CITY OF LA VISTA
MAYOR AND CITY COUNCIL REPORT
MARCH 16, 2021 AGENDA

Subject:	Type:	Submitted By:
HARRISON HILLS REPLAT SEVEN – (REPLAT & SUBDIVISION AGREEMENT)	◆ RESOLUTIONS (2) ORDINANCE RECEIVE/FILE	CHRISTOPHER SOLBERG DEPUTY COMMUNITY DEVELOPMENT DIRECTOR

**CITY OF LA VISTA
PLANNING DIVISION
RECOMMENDATION REPORT**

CASE NUMBERS: PRP20-0002;

POST CONSTRUCTION STORM WATER MANAGEMENT PLAN

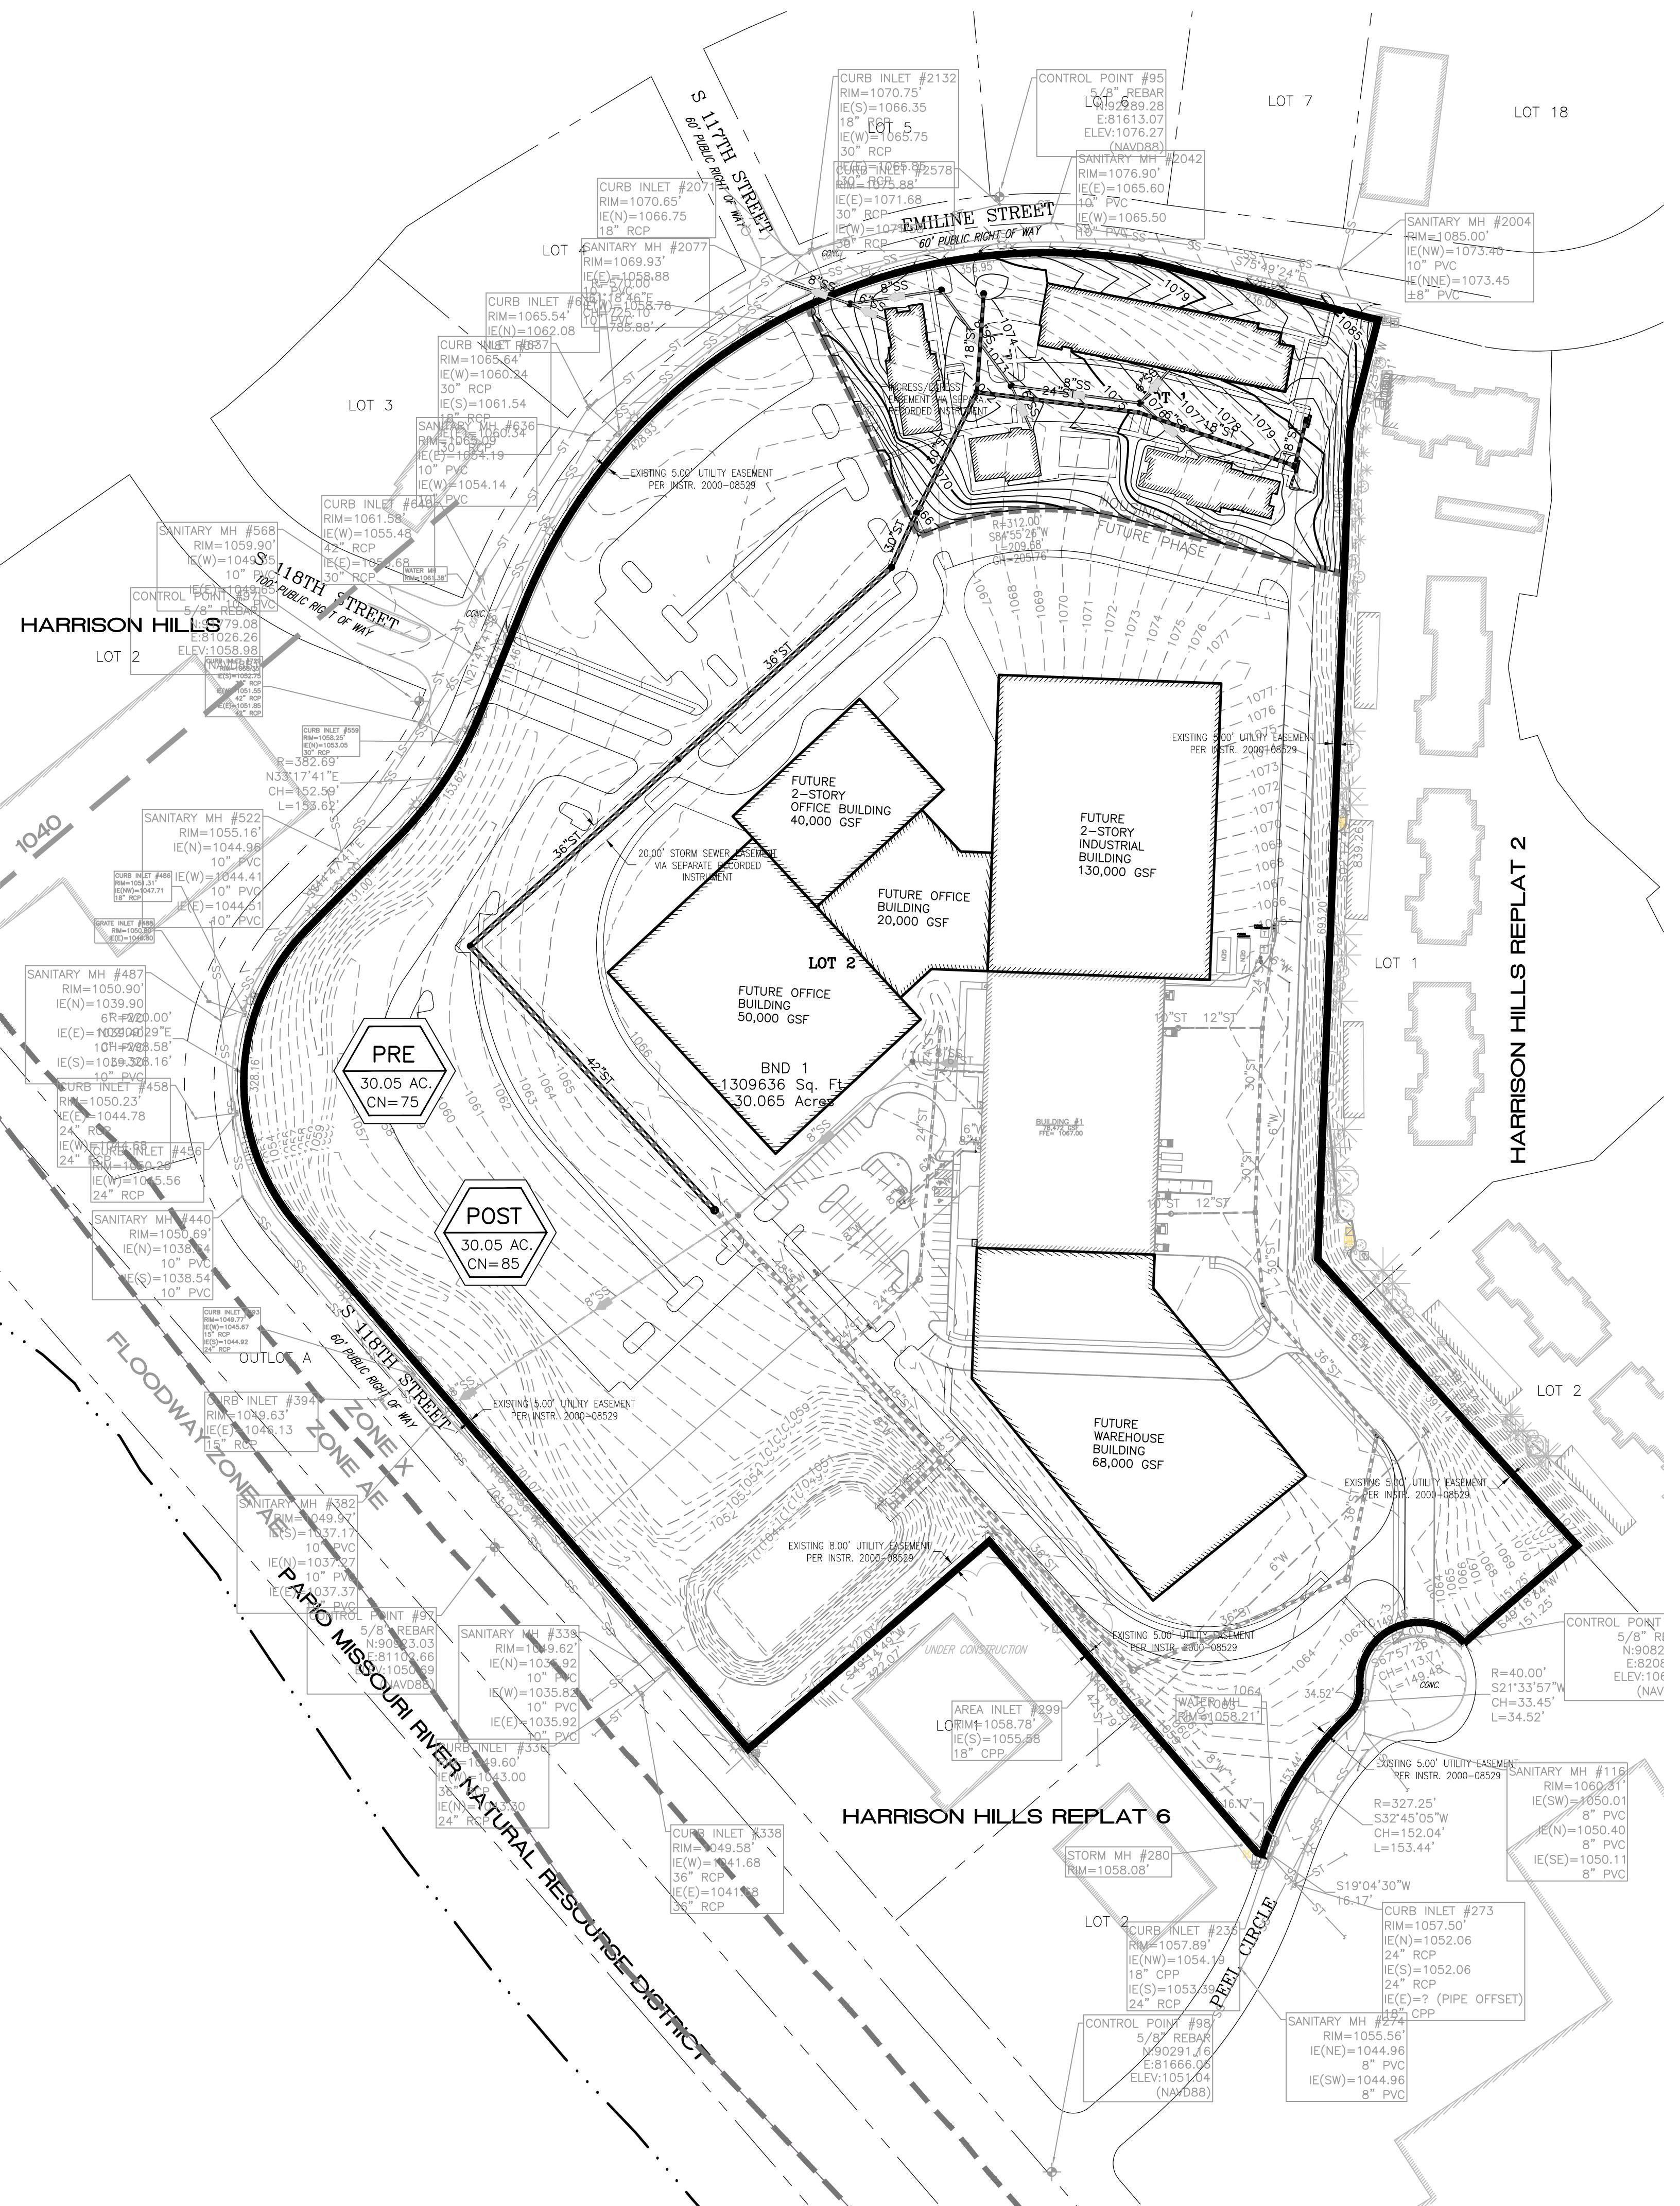
7. Section 3.07.03, Section 3.03.15 – The Post Construction Storm Water Management Plan shows dry detention basin that will be conveying drainage from Lot 1 through a permanent storm sewer easement in Lot 2. The intent of the maintenance is unclear as to if Lot 1 will be required to contribute to the maintenance of the dry detention basin, or if Lot 2 will be solely responsible for the operation and maintenance of the BMP. If the intent is to have both lots share in the maintenance as a common area, this will need to be depicted, and a subdivision agreement is likely necessary.

7. Section 3.07.03, Section 3.03.15 – The Post Construction Storm Water Management Plan shows dry detention basin that will be conveying drainage from Lot 1 through a permanent storm sewer easement in Lot 2. The intent of the maintenance is unclear as to if Lot 1 will be required to contribute to the maintenance of the dry detention basin, or if Lot 2 will be solely responsible for the operation and maintenance as a common area, this will need to be depicted, and a subdivision agreement is likely necessary.

Response: The maintenance of the dry detention basin will be outlined in the subdivision agreement.

GRADING PLAN

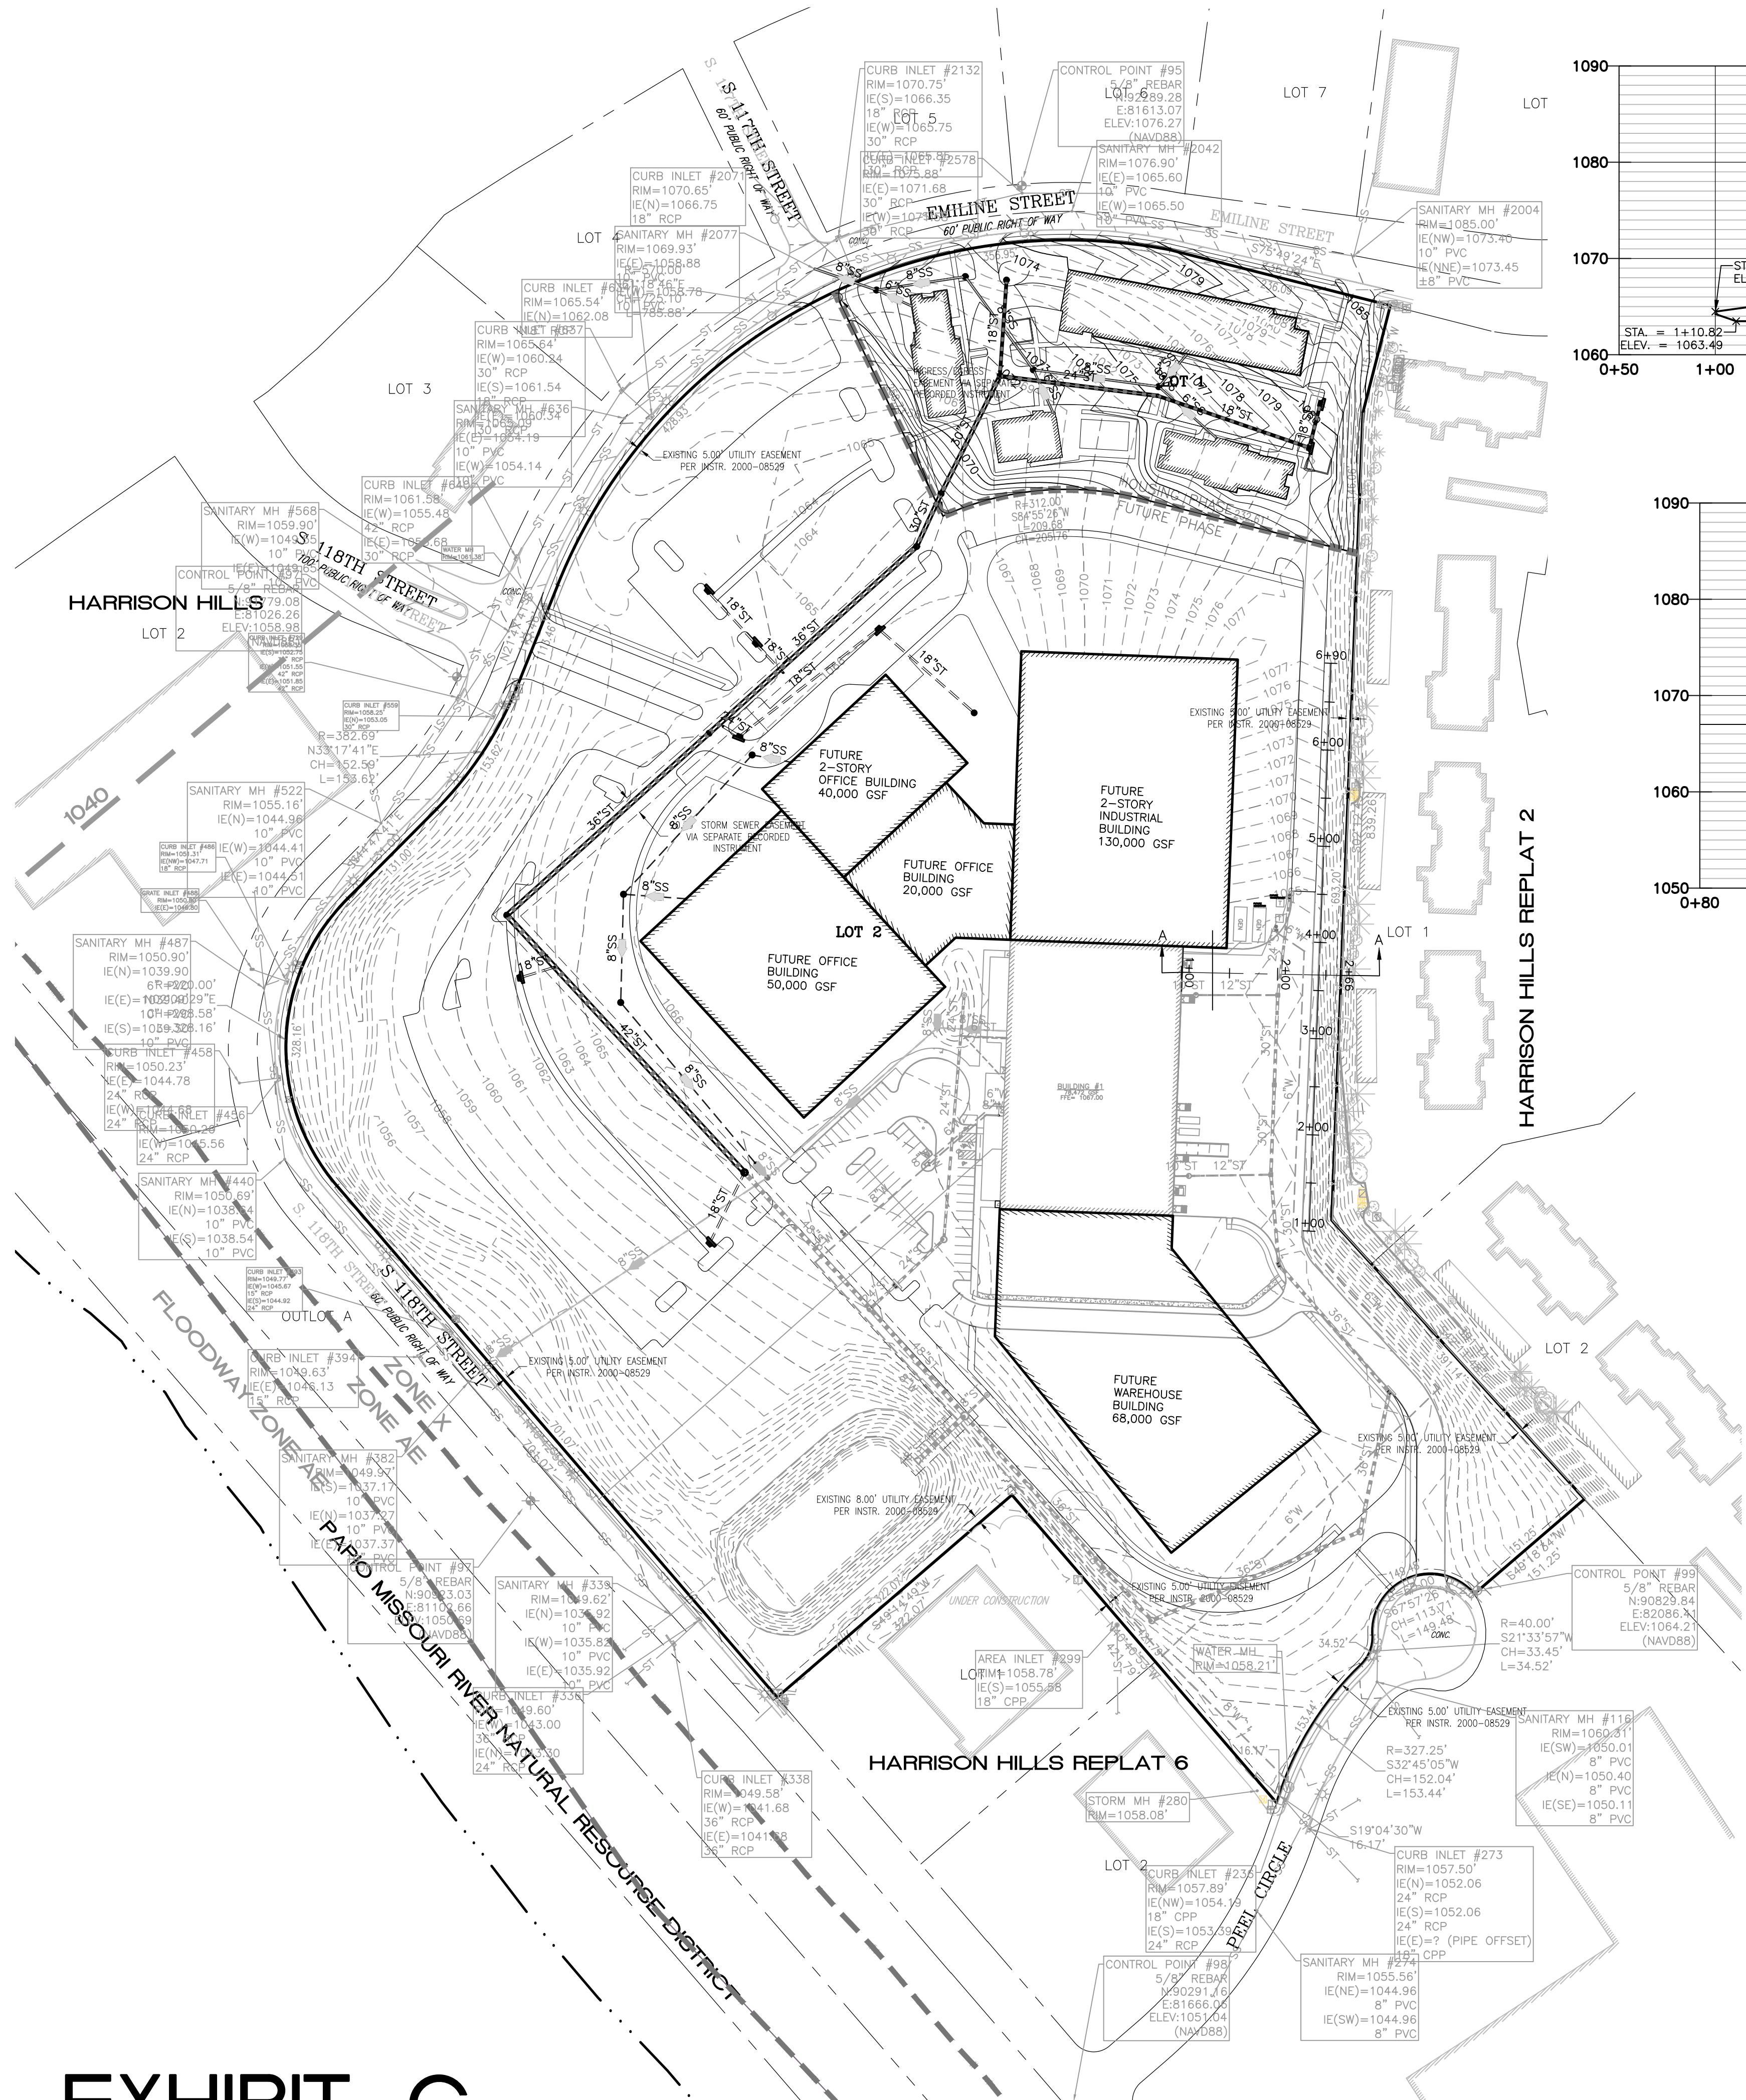
1. Section 3.07.03, Section 3.03.02 – Topography needs to be updated as to show current existing grades vs. proposed grading for the next phase.

Response: The topography shown on the preliminary plat has been updated to show the site's existing grades. Exhibit G has been added to show the proposed grading for the housing phase.
